DOCUMENT 009101

ADDENDUM NO. 1

DATE: FEBRUARY, 9, 2021
TO: PROSPECTIVE BIDDERS
FROM: CROWLEY COTTRELL LANDSCAPE ARCHITECTURE, LLC
171 MILK ST, FL2
BOSTON, MA 02109

Fig. 1: Image showing appearance of exposed aggregate concrete pad at Academy St. Entrance to Arlington Town Hall.

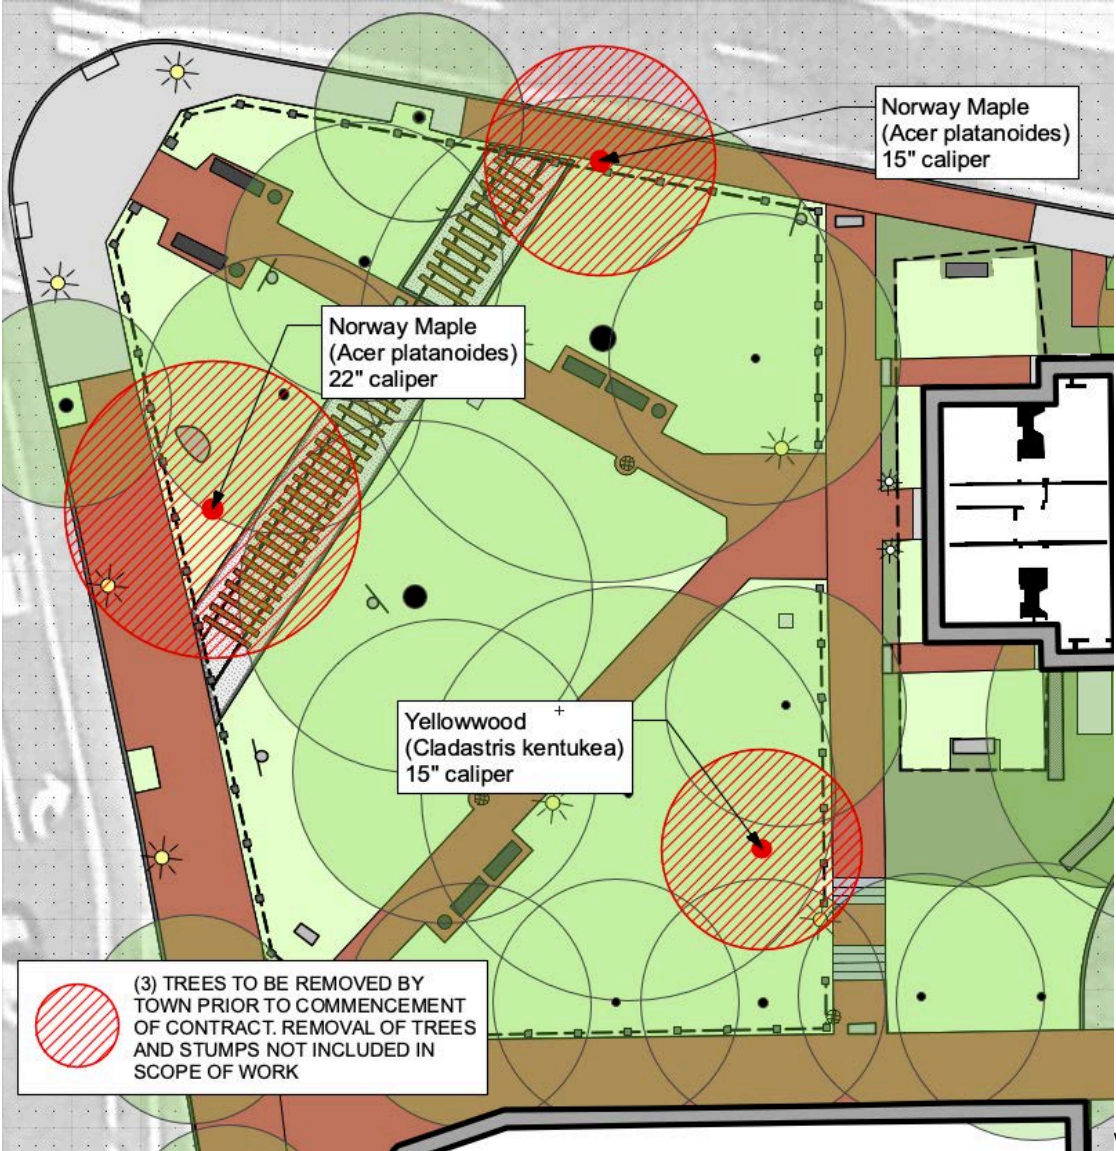
3. Q: Will mockups be required for the exposed aggregate concrete?
A: Yes, mockups are required. Attached is a photograph (Fig. 1) of a pad of exposed aggregate concrete located at the Academy St. Entrance to Arlington Town Hall, which can be used as a general reference for the desired effect at Whittemore Park.
4. Q: Does the town want to salvage the granite piers removed from the site?
A: The Town of Arlington does not want to salvage any of the granite piers removed from site. Any granite piers that are removed and not relocated on site as per drawings on L-101 and L-200 are to be disposed of at the contractor’s discretion.
